**CITY PLAN COMMISSION
Agenda**

**Thursday, November 19, 2015 at 5:00 pm
Municipal Building
625 52nd Street - Room 202 - Kenosha, WI 53140**

Date: November 10, 2015
Subject: Plan Review Comments
Project Description: Ameche Field Renovations
Location: 8730 22nd Avenue

Location: 8730 22nd Avenue

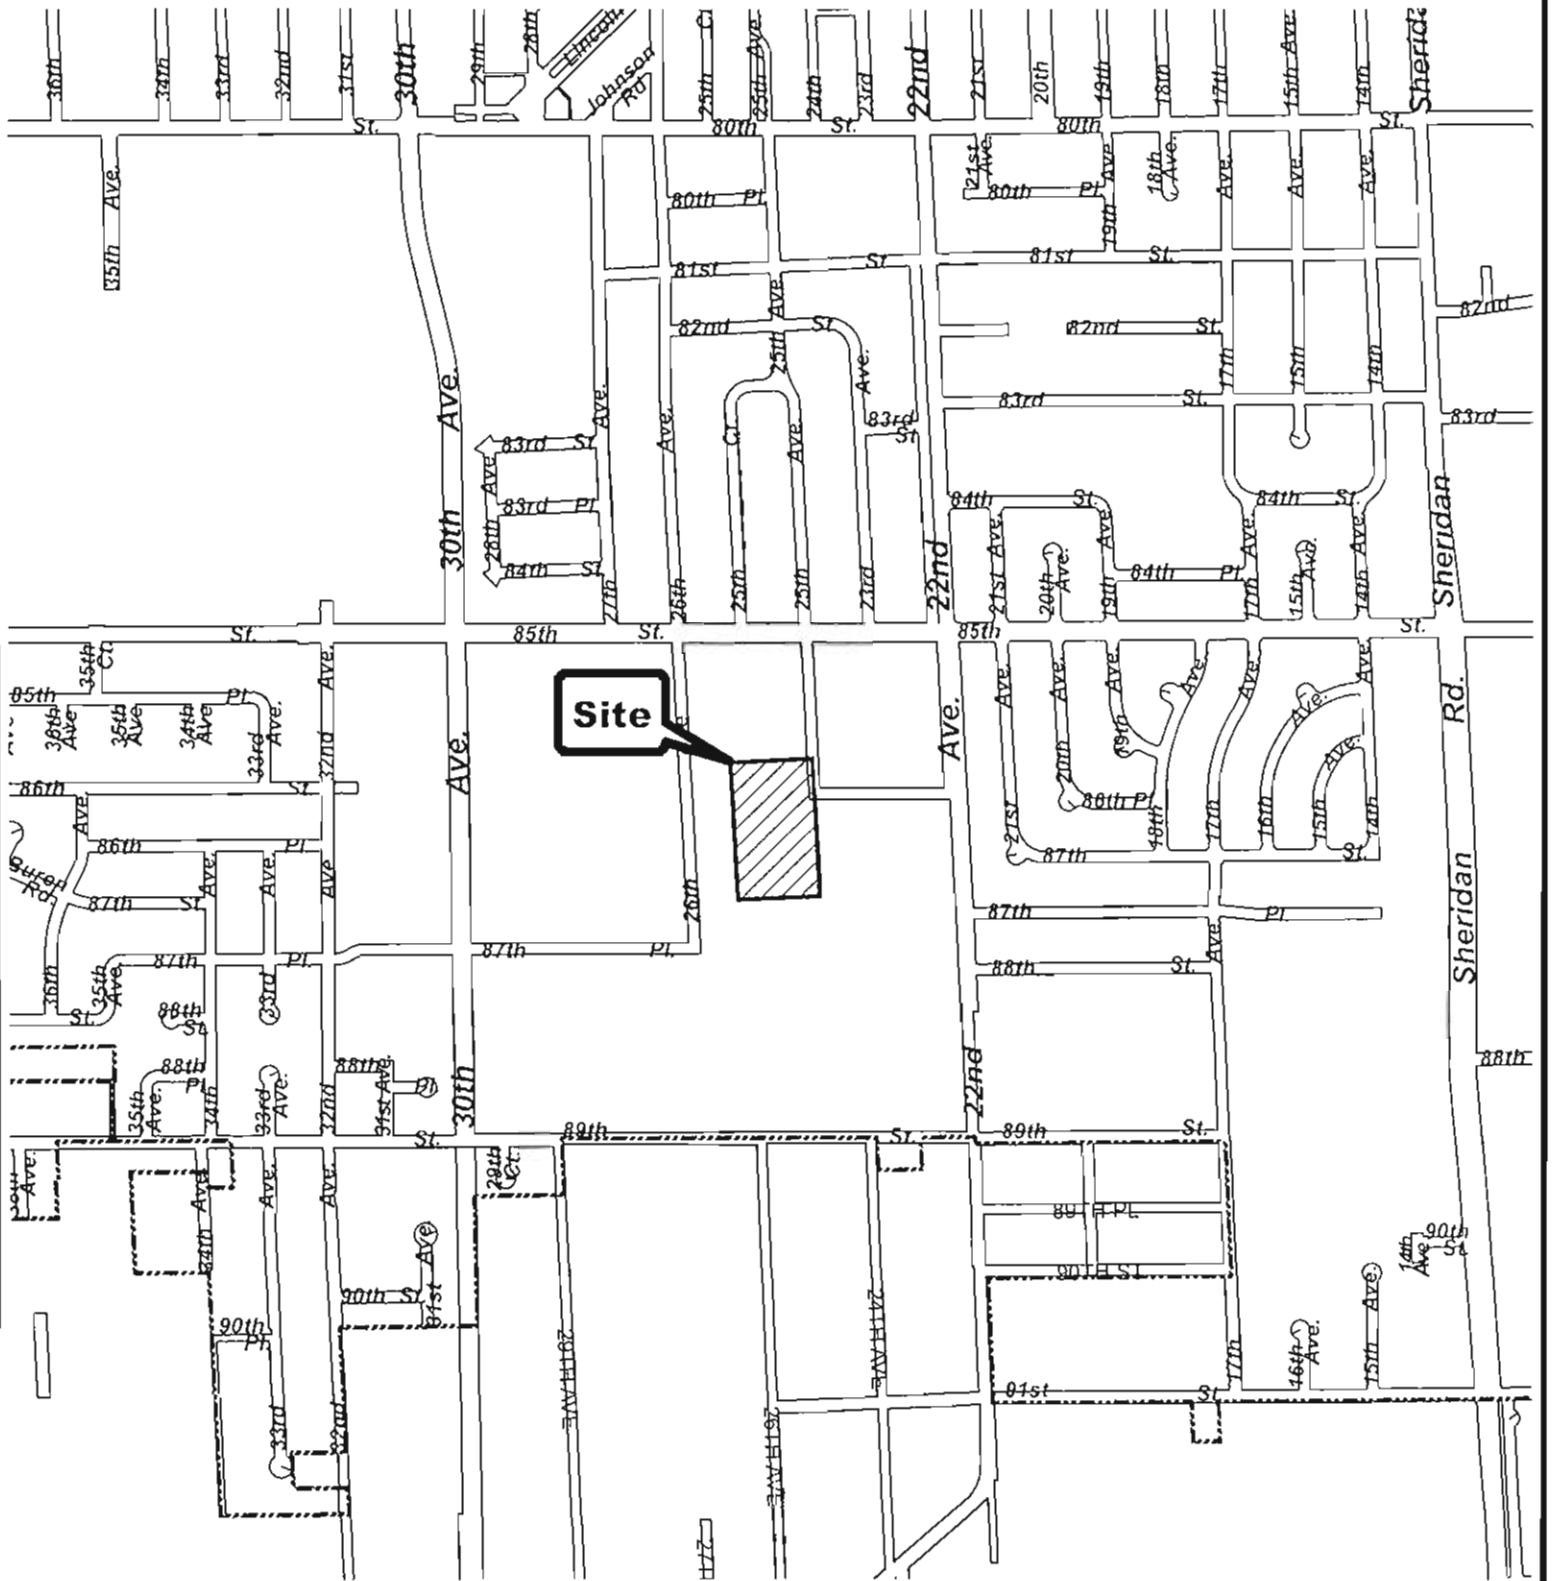
1. Show the water meter size and location, including a detail or diagram, on the construction plans, not with the MEP submittal. The water meter shall have unobstructed access, twelve inches (12") from the inside wall, twelve to twenty-four inches (12"-24") above the floor. The meter shall have a valve, preferably ball style, on the inlet and outlet pipe.

2. All water meters one and one half inches (1-1/2") or greater shall have a bypass with a two way ball valve with locking handle as manufactured by RuB, or approved equal.

4. The eight inch (8") water main relay shall be flushed and bacteria tested in accordance with KWU Chapter XXXII Rules & Regulations, Rule 06-35.
5. There are no specifications for water or sanitary sewer service materials or installation shown on the plans.

10. The existing sanitary sewer is six inches (6") in diameter at Junction 20.0, not eight inches (8") as the plans show. The connection shall be made using a "cut-in-wye" and installed by core drilling a hole in the main and attaching a flexible rubber tee or wye saddle with stainless steel clamps. This connection may also be made using an Inserta Tee, installed according to the manufacturer's recommendations. The sanitary sewer connection will need to be inspected by KWU. Notify KWU 48 hours in advance of connecting to the sewer.

Location: 3700 Washington Road

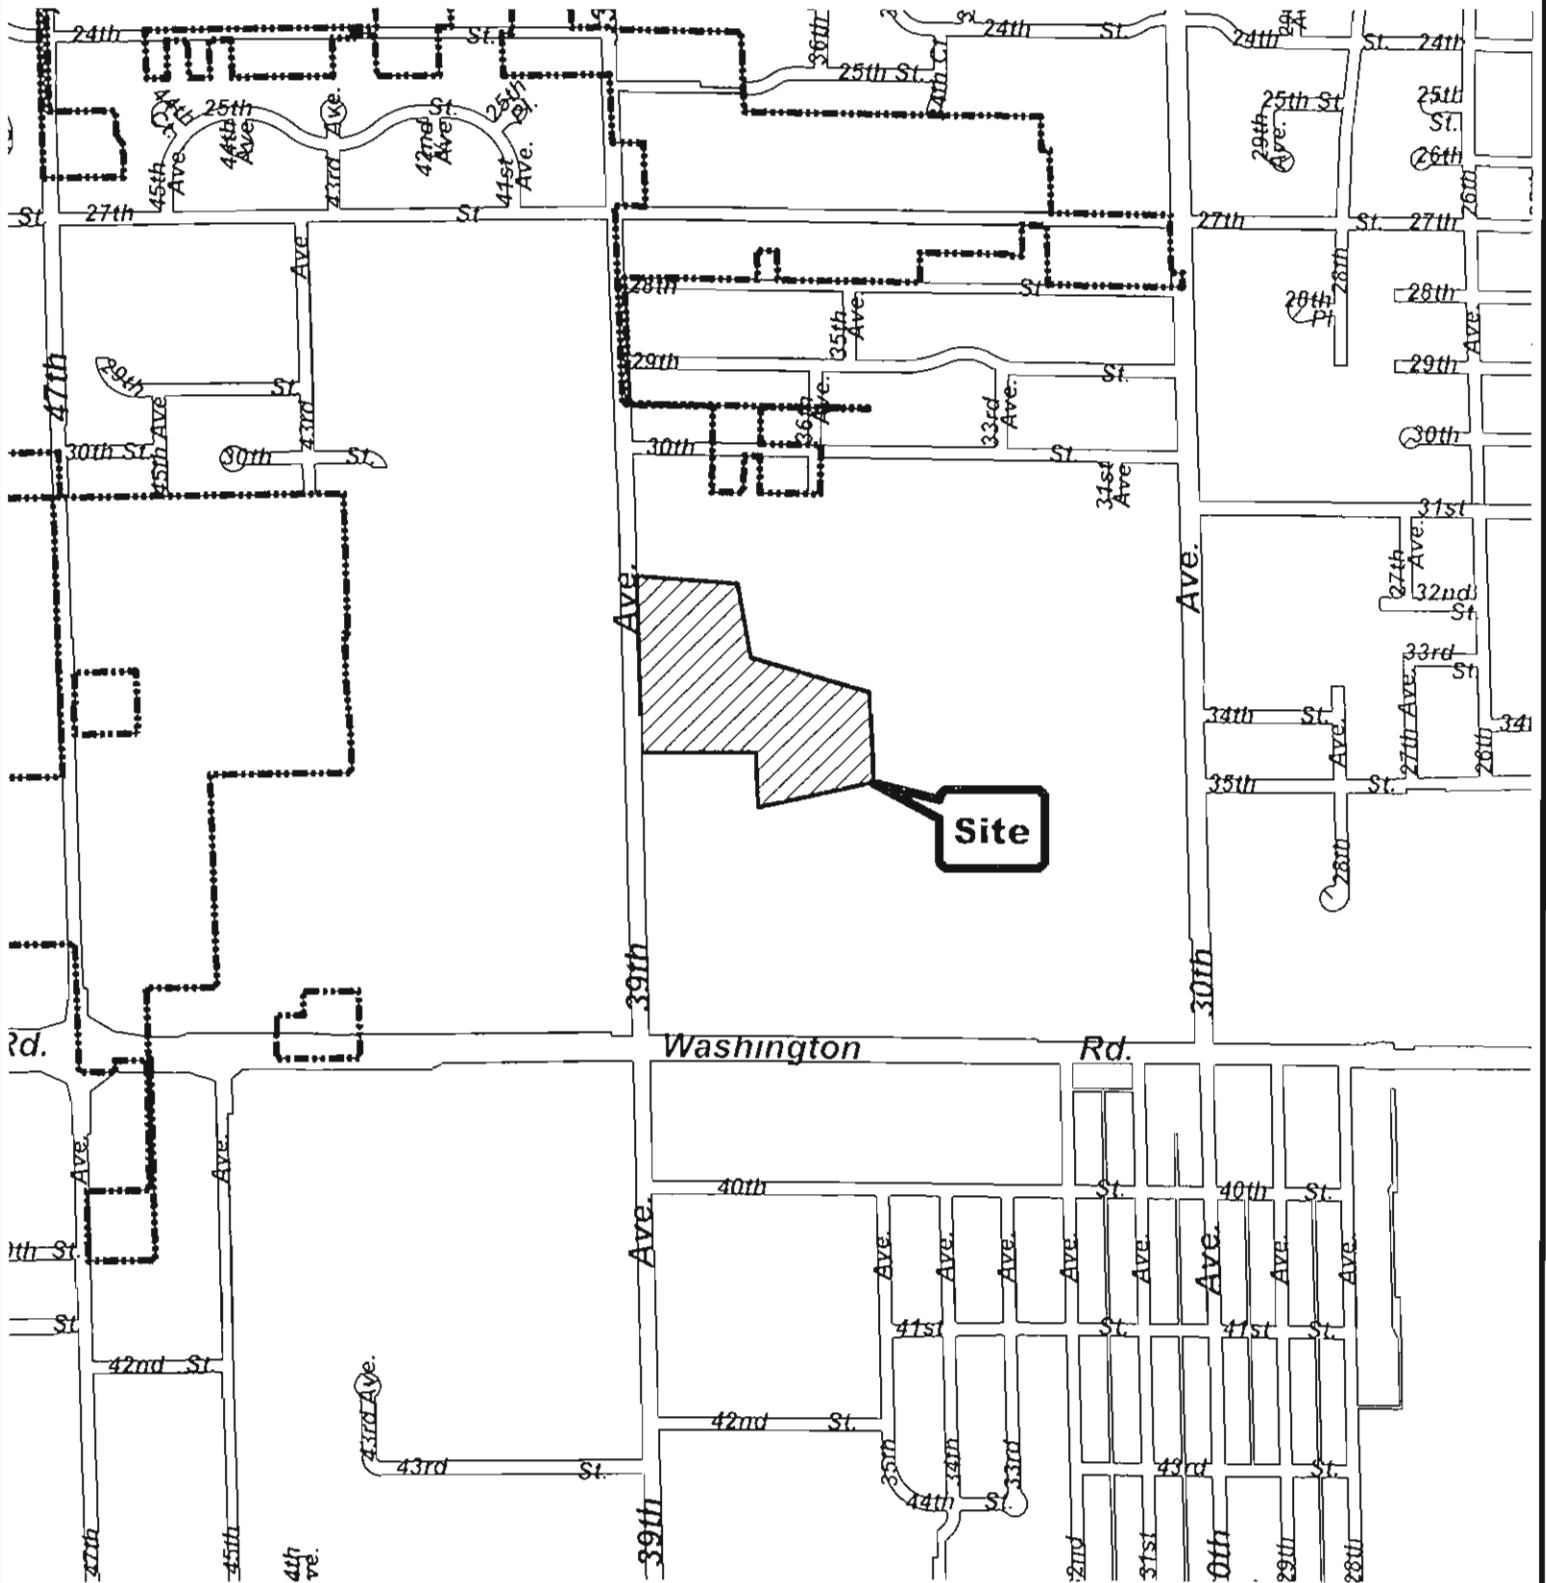
1. The proposed improvements are being constructed within a 60' KWU sanitary sewer easement. It is our position that trench restoration for any sanitary sewer repairs will be the responsibility of KWU but restoration of the proposed improvements will be the responsibility of the Kenosha Unified School District.

2. Show the water meter size and location, including a detail or diagram, on the construction plans, not with the MEP submittal. The water meter shall have unobstructed access, twelve inches (12") from the inside wall, twelve to twenty-four inches (12"-24") above the floor. The meter shall have a valve, preferably ball style, on the inlet and outlet pipe.

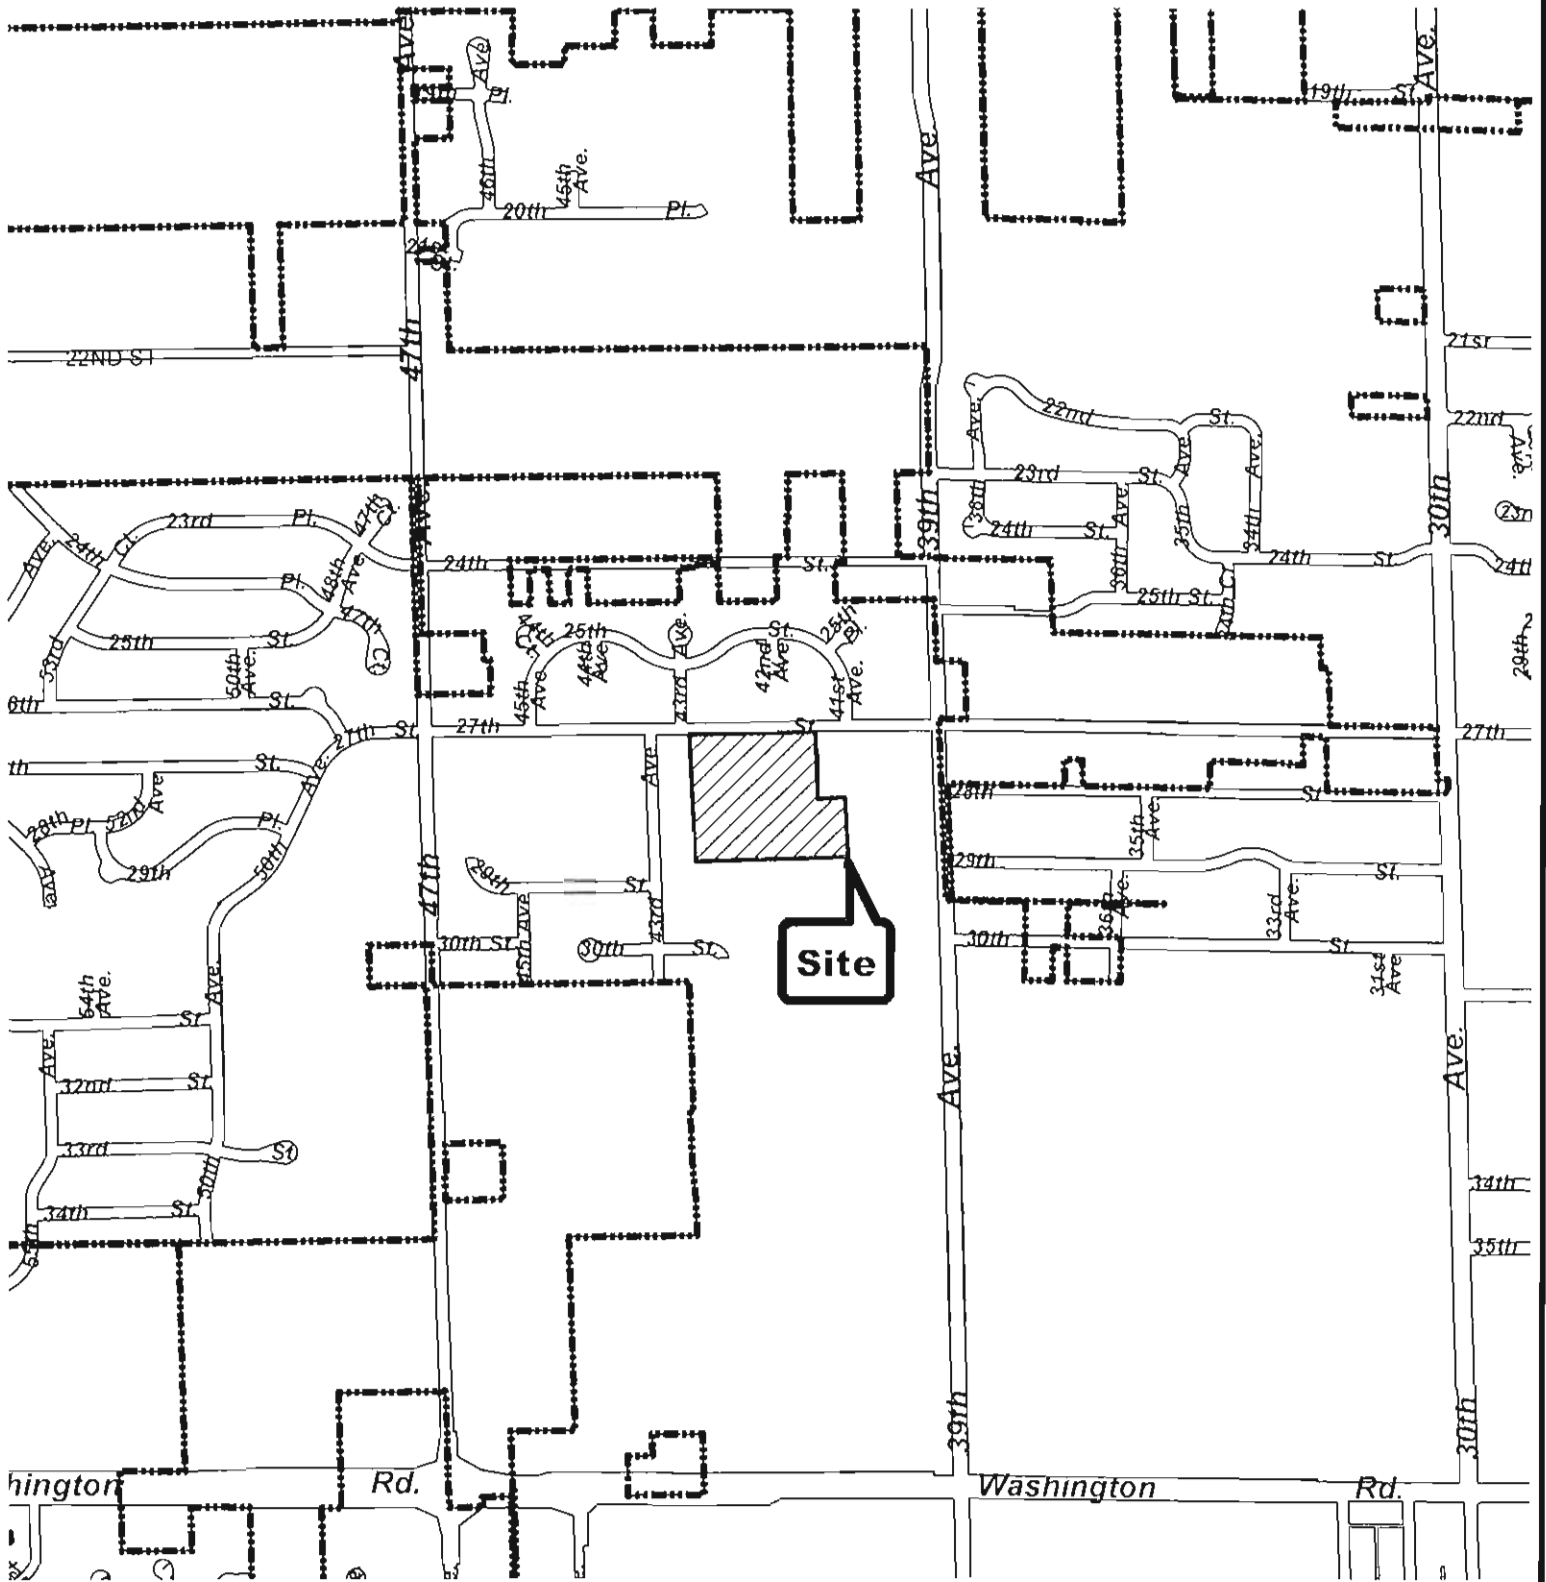
7. The Utility Legend and the Water Main Design table conflict regarding the size of the water service. Also, STUB 1.0 is shown in table but is not referenced on the plan.

8. The sanitary sewer connection shall be made using a "cut-in-wye" and installed by core drilling a hole in the main and attaching a flexible rubber tee or wye saddle with stainless steel clamps. This connection may also be made using an Inserta Tee,

installed according to the manufacturer's recommendations. The sanitary sewer connection will need to be inspected by KWU. Notify KWU 48 hours in advance of connecting to the sewer.

9. There are no rim elevations given for SAN MH 6.0 or 7.0.
10. Sanitary sewer laterals shall have a green 12 gauge locator wire installed along the entire length. Locator wire shall be brought to the surface at the edge of the building and enclosed in a locator box with "sewer" on the cover.
11. "Internal / External" manhole seals as manufactured by Adaptor, Inc. shall be provided for each private sanitary sewer manhole installed. A detail for the seal can be found at <http://www.adaptorinc.com/pdf/jnexaspec.pdf>.

Subject: Tremper High School Athletic Improvements

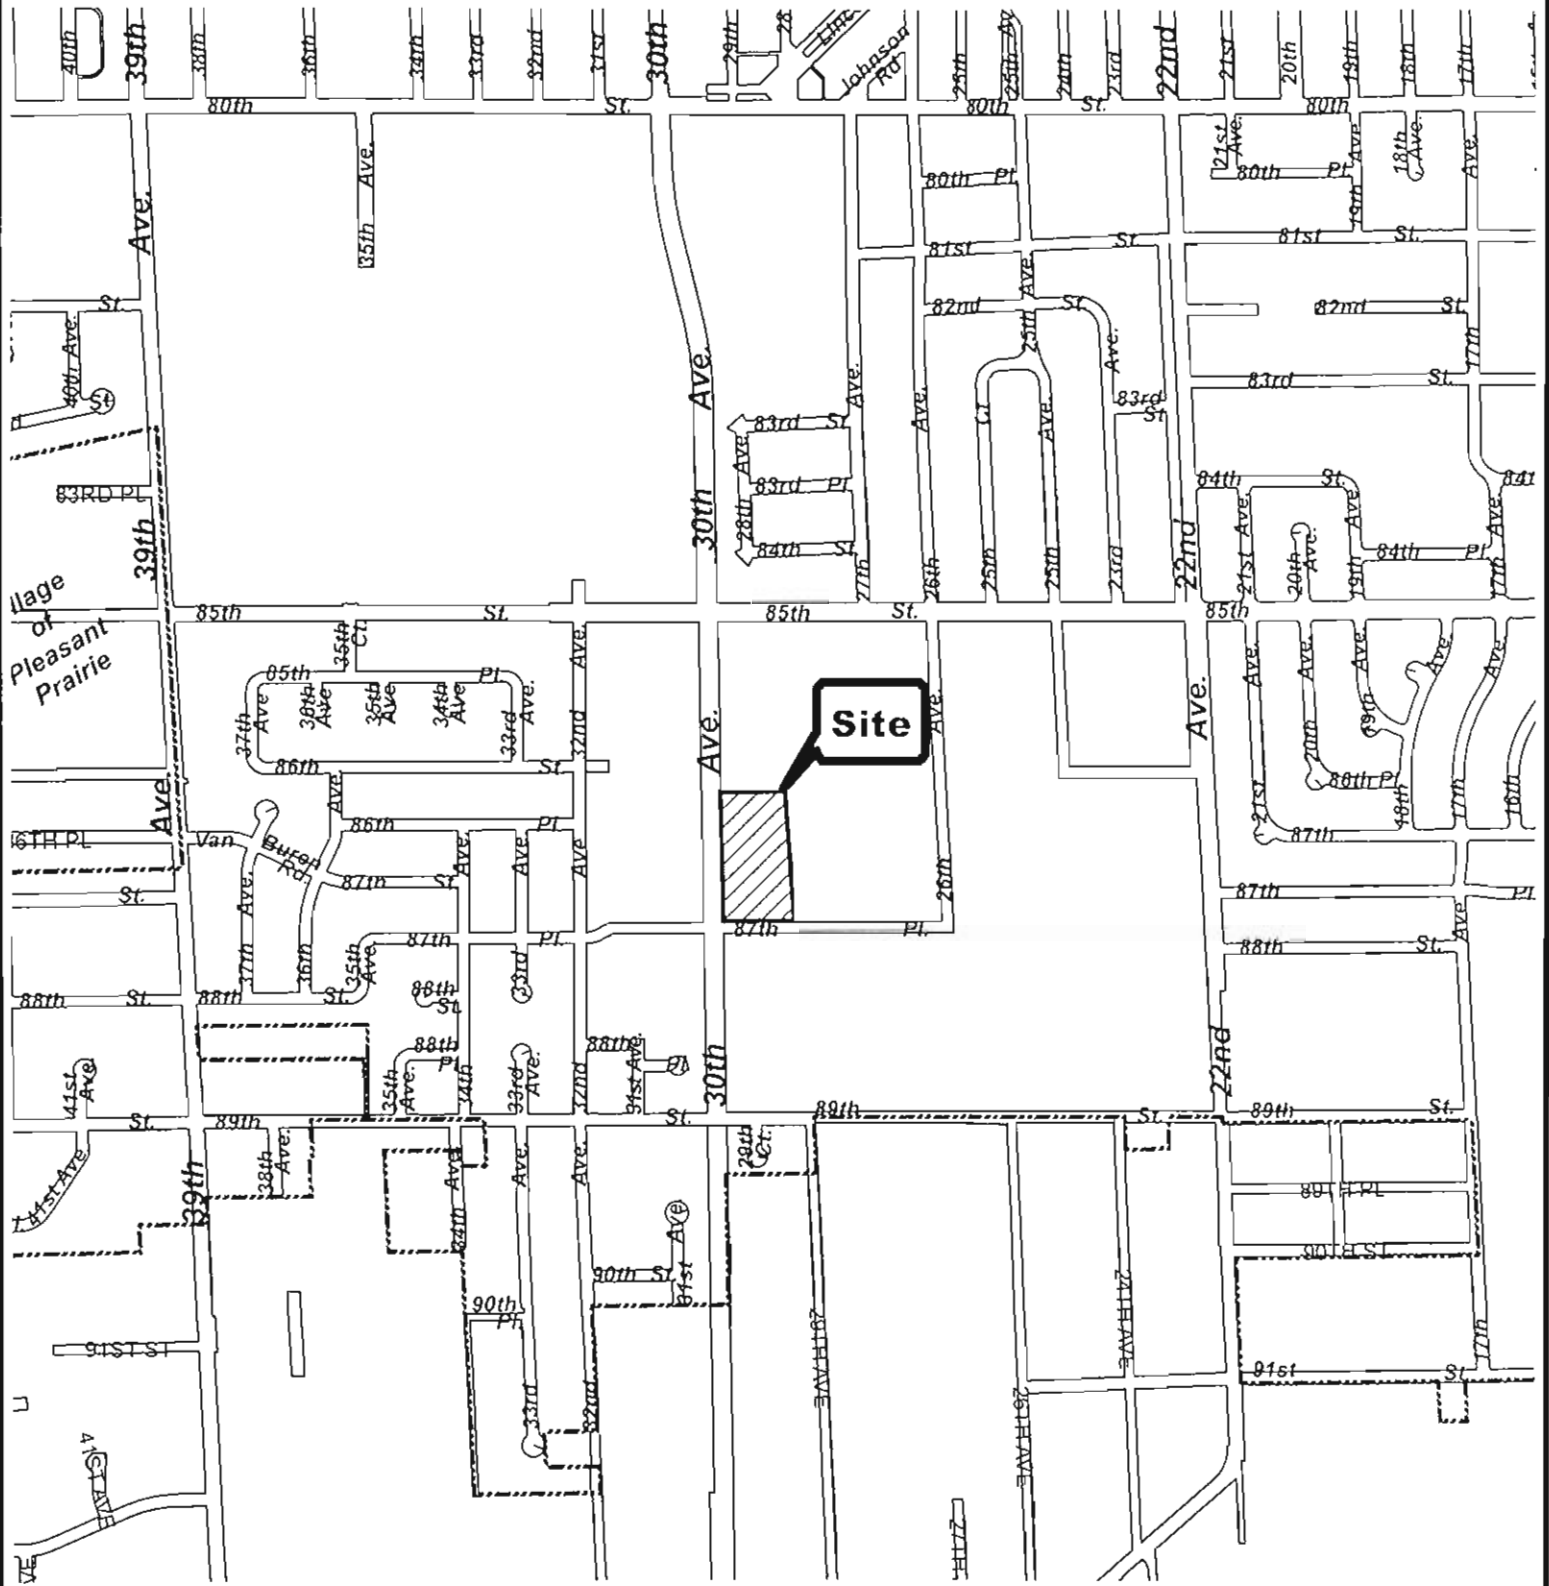
1. Show the water meter size and location, including a detail or diagram, on the construction plans, not with the MEP submittal. The water meter shall have unobstructed access, twelve inches (12") from the inside wall, twelve to twenty-four inches (12"-24") above the floor. The meter shall have a valve, preferably ball style, on the inlet and outlet pipe.
